Reference: Notice of Project Technical Change – Gunn's Hill Wind Farm

Prowind Canada Inc. (Prowind) on behalf of Gunn's Hill Windfarm Inc. proposes to install and operate the 18 MW Gunn's Hill Wind Farm (the Project) in the Township of Norwich, Oxford County, Ontario (Project mapping is provided in **Attachment A**). The Renewable Energy Approval (REA) application package for the Gunn's Hill Wind Farm was received by the Ministry of Environment and Climate Change (MOECC) on June 10, 2013, and the application was deemed complete on February 7, 2014. The Project is currently under technical review with the MOECC. The purpose of this letter is to inform the MOECC of the addition of a second road design and construction option to the Project. Please note there is no change in location of the access roads, and no change in the overall Project Location.

ACCESS ROAD DESIGN AND CONSTRUCTION

Gunn's Hill Wind Farm Layout

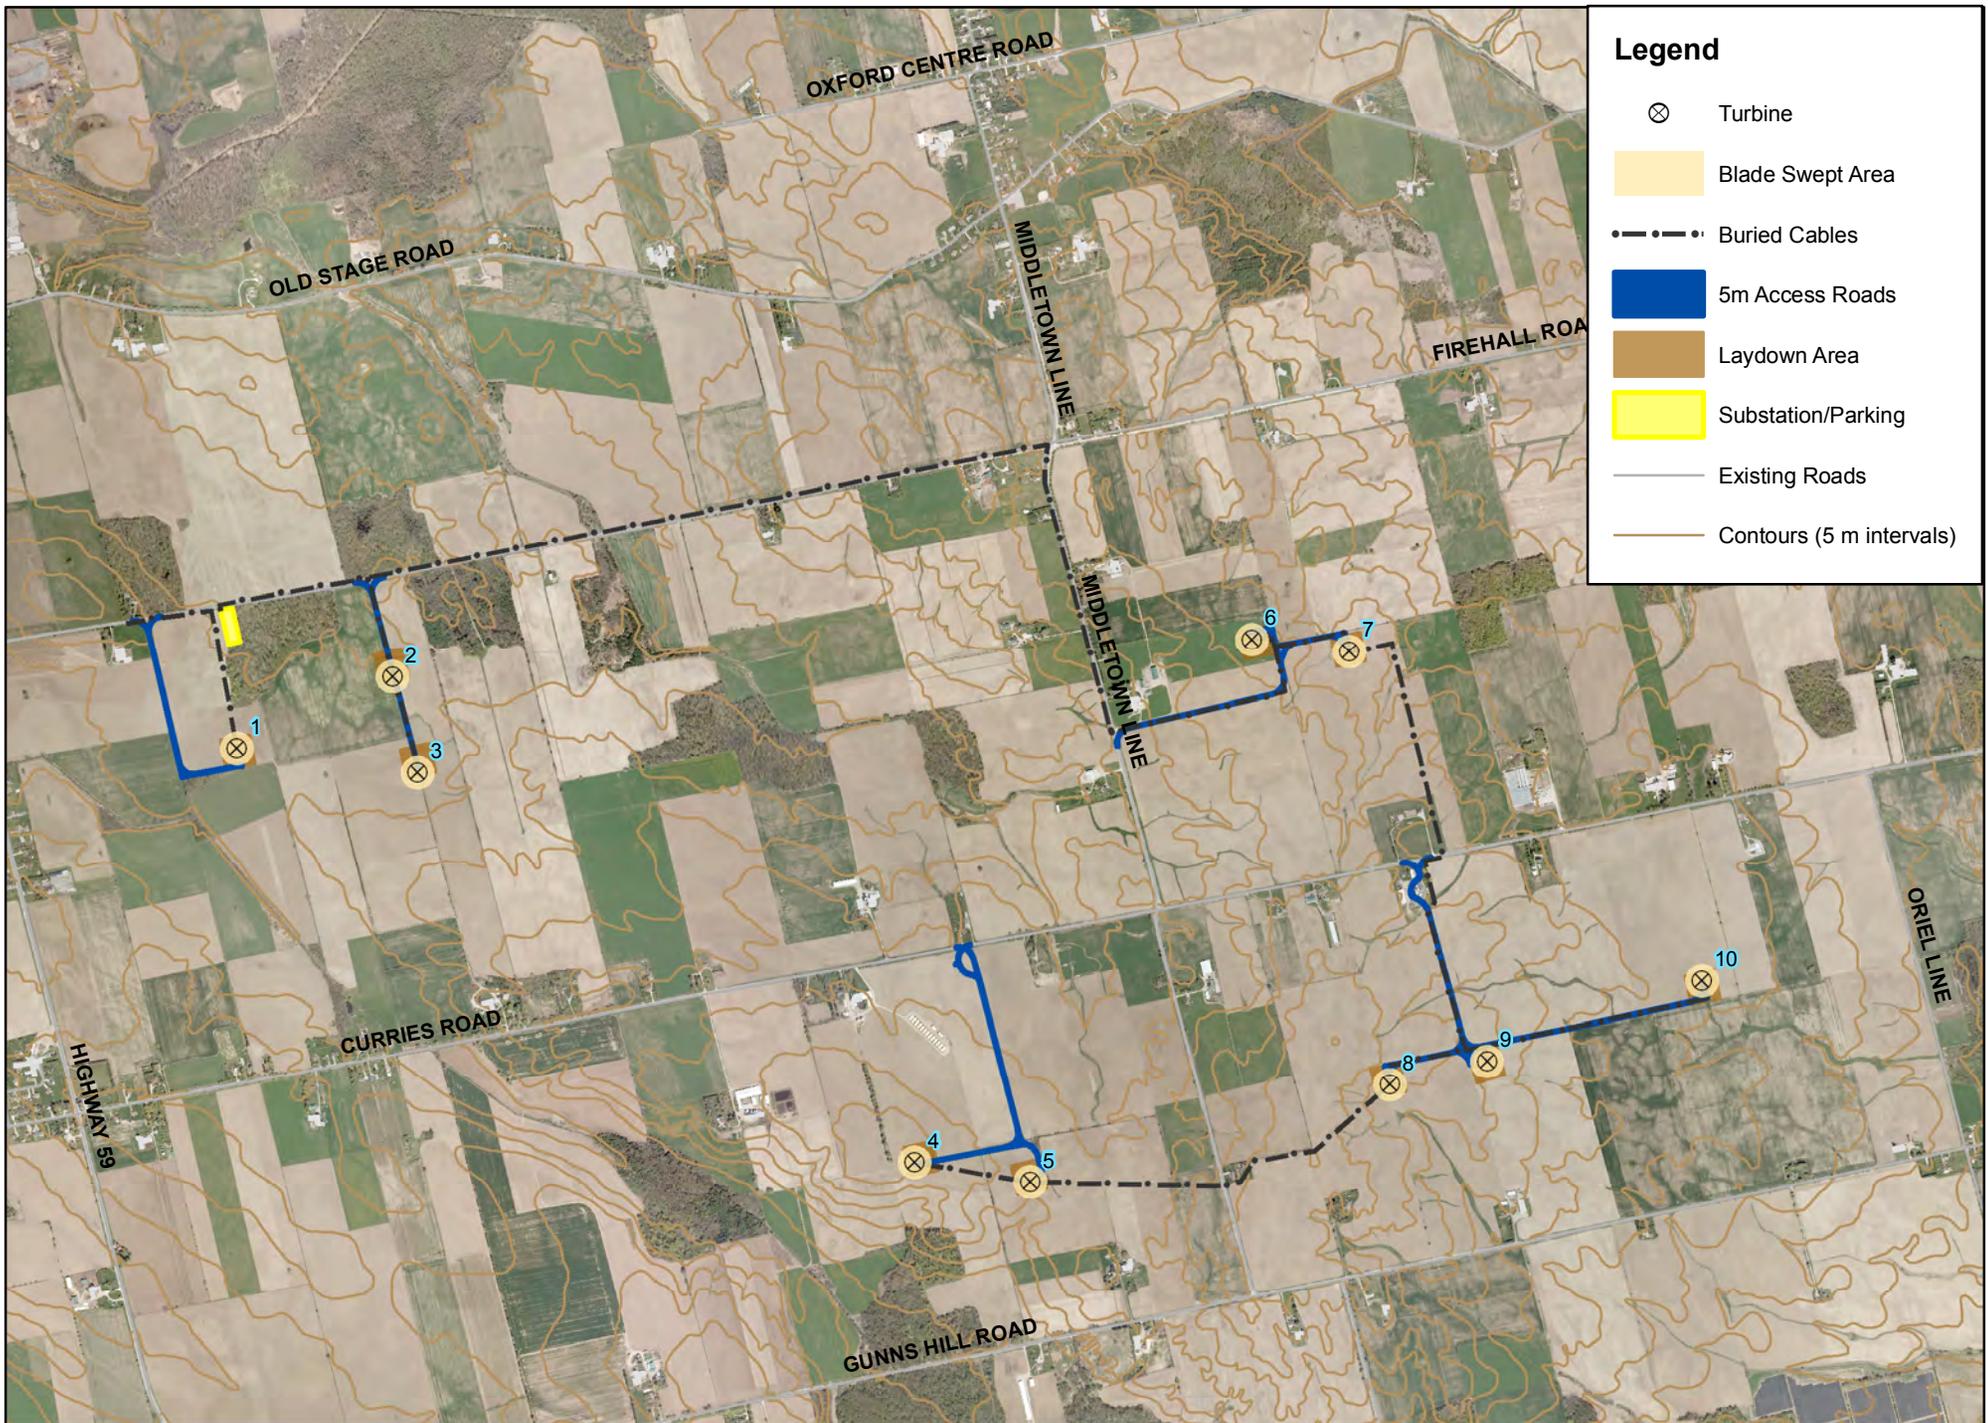
Access roads will be built to a width of 5 m during construction and will remain at 5 m during operation. The Construction Plan Report stated between 6-11 m width during construction (depending on location), reduced to 5 m during operation. Therefore, there is a reduction in the potential impact from access road construction as the disturbed area is significantly reduced.
